Re: The City of Benicia's Revised Draft Environmental Impact Report for the
Valero Benicia Crude-by-Rail Project

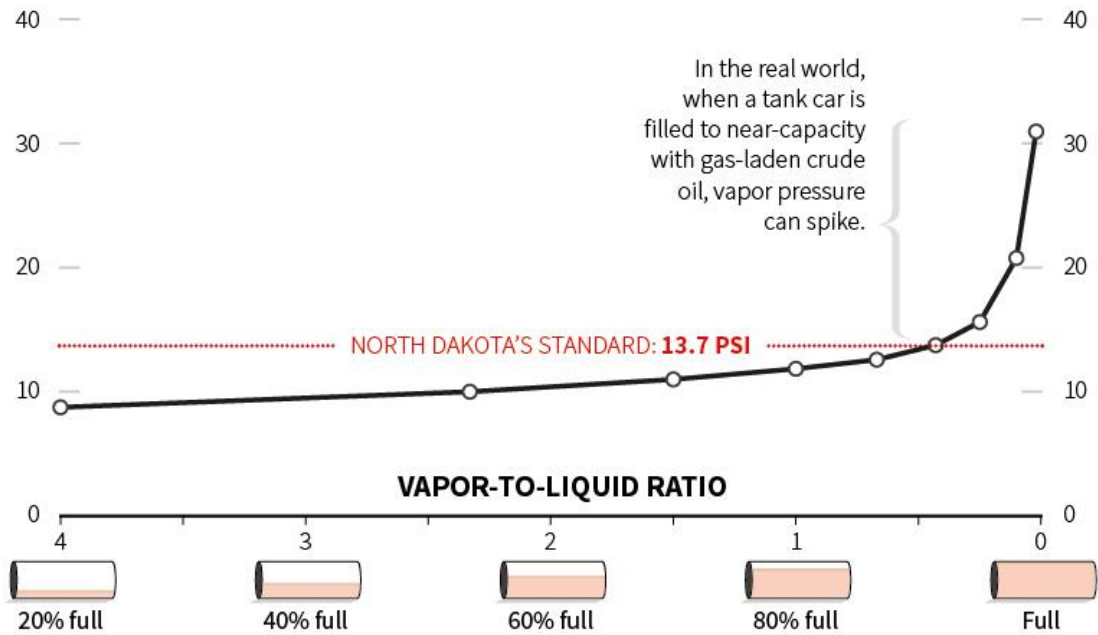
5) As the refineries in the Bay Area have been more intensively processing crudes, generally and using heavier crude slates within the past decade and a half, greenhouse gas and particulate matter (PM) have steadily increased in parallel. These linked GHG-PM increases have occurred despite progress made in reducing such pollutants as sulfur dioxide. These GHG and co-pollutant PM increase data are derived by CBE from data from the State's California Air Resources Board (CARB) and the nine-county Bay Area Air Quality Management District (BAAQMD, which is under the auspices of CARB). Particulate matter increases are a public health concern, such as regarding asthma, which would be aggravated by the increased local processing of bitumen. I have included this data as attached graphs, below:

Vapor pressure in oil trains

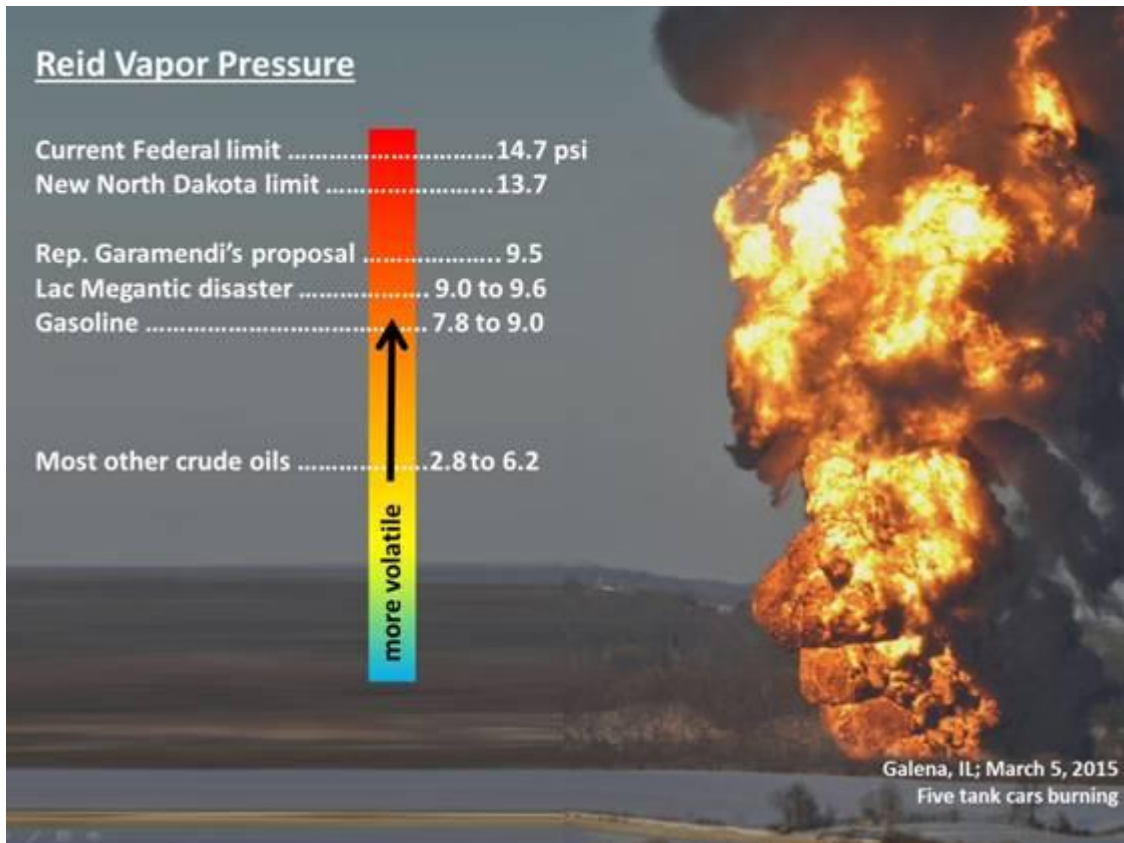
North Dakota's standard will detect vapor pressure using a mostly-empty container but tank cars are practically fully-loaded when they move from field to refinery. Vapor pressure can rise significantly above the state's 13.7 psi threshold in real-world conditions.

7) Another consequence of Bakken's high vapor pressure is that the pressure will tend to drive out of solution, into the environment, much more toxic hydrocarbon vapors, such as highly carcinogenic benzene. (See above, Bakken crude PSI data from Amatek and Sandia National Laboratories.)
